<b>Subject:</b>  HARD SHIFTING/SHIFT LEVER VIBRATION	<b>Bulletin No:</b> 05-001/15
	<b>Last Issued:</b> 11/30/2015

## BULLETIN NOTE

- This bulletin supersedes the previous bulletins 05-001/15 issued on 11/11/15, 05-008/14 issued on 07/14/14 and 11/26/14 and 05-001/15 issued on 01/05/15. The PART(S) INFORMATION has been revised.
- Changes are noted below in Red beside the change bar.

### Location of Transmission Related Parts

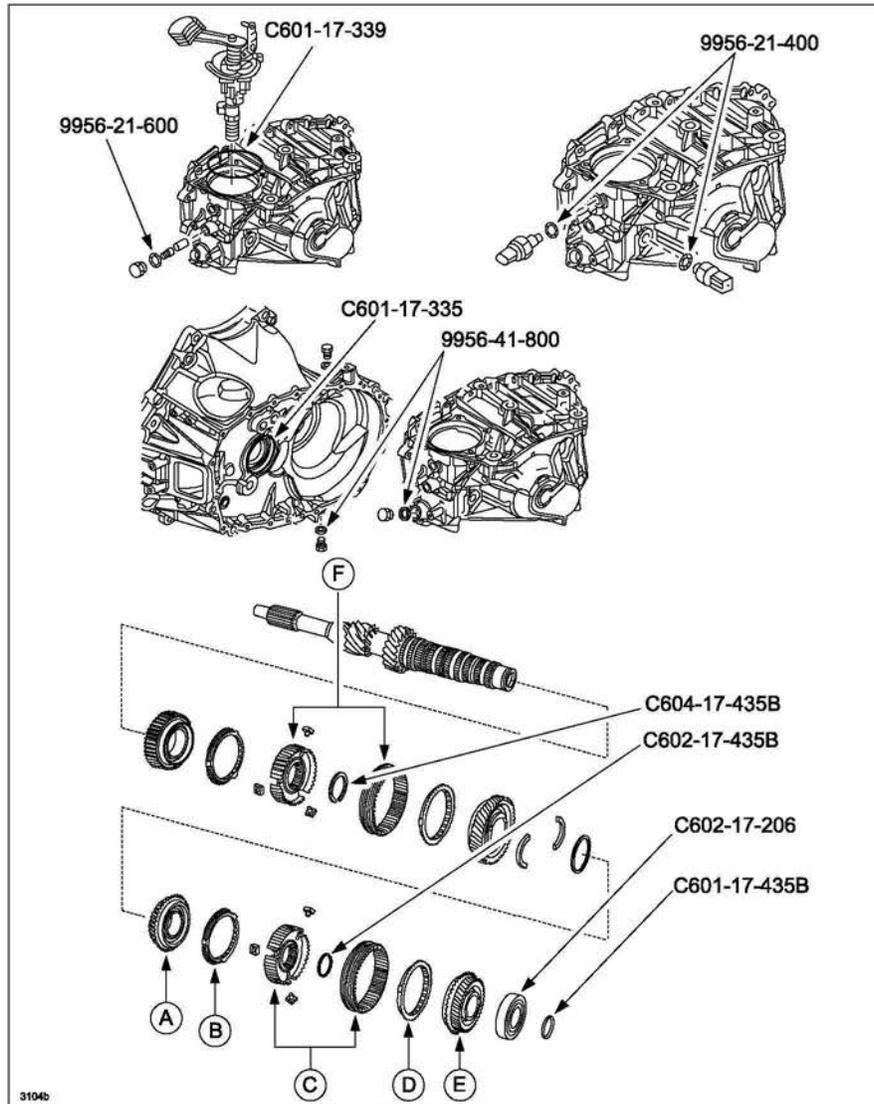
Modification	Mass-Production Change		Subject Concern
	Subject Part	Changes	
A	3-4 Clutch Hub	Surface treatment	Jumping out of gear
B	3-4 Clutch Hub 5-6 Clutch Hub	Shape	Hard shifting into 3rd, 4th, 5th and/or 6th gear
C	3rd and 4th Gears	Tolerance	Shift lever vibration
D	3rd and 4th Gears 3rd and 4th Synchronizer Rings	Shape	Hard shifting into 3rd and/or 4th gear (additional improvement)

VINs	Symptom			
	Gear jumping out (3rd Gear)	Hard shifting (5th or 6th Gear)	Hard shifting (3rd or 4th Gear)	Shift lever vibration (3rd or 4th Gear)
VINs before Modification A	Replace: 1) 3/4 Clutch Hub 2) 3rd Gear and Synch. Ring	Replace: 1) 5/6 Clutch Hub	Replace: 1) 3/4 Clutch Hub 2) 3rd Gear and Synch. Ring 3) 4th Gear and Synch. Ring	Replace: 1) 3rd Gear and Synch. Ring 2) 4th Gear and Synch. Ring
VINs between Modification A and B				
VINs between Modification B and C			Replace: 1) 3rd Gear and Synch. Ring 2) 4th Gear and Synch. Ring	
VINs between Modification C and D

Part Number	Description	Qty.	Notes
C602-17-240B	3-4 Clutch Hub Assembly	1	
<b>C602-17-620C</b>	5-6 Clutch Hub Assembly	1	
C601-17-230D C610-17-230C	3rd Gear	1	Part numbers of gears are different depending on the variation of the gear ratio. Check EPC for the correct part number for the repair VIN.
C602-17-26YB	Synchronizer Ring	2	
C601-17-210E C603-17-210B C613-17-210B	<b>Gear, Main Drive</b>	1	
<b>F401-17-313</b>	<b>Reamer Bolt</b>	<b>6</b>	Replacement parts that are necessary for all repairs.
C601-17-435B	Retaining Ring	1	
C604-17-435B	Retaining Ring	1	
D602-17-435B	Retaining Ring	1	
C602-17-206	Ball Bearing	1	
C601-17-339	"O" Ring	1	
C601-17-335	Oil Seal	1	
9956-21-400	Washer	2	
9956-21-600	Washer	1	
9956-41-800	Washer	2	
0000-77-5W80-QT	Manual Transaxle Oil	3	Specification: 2.6 - 2.7 US qt
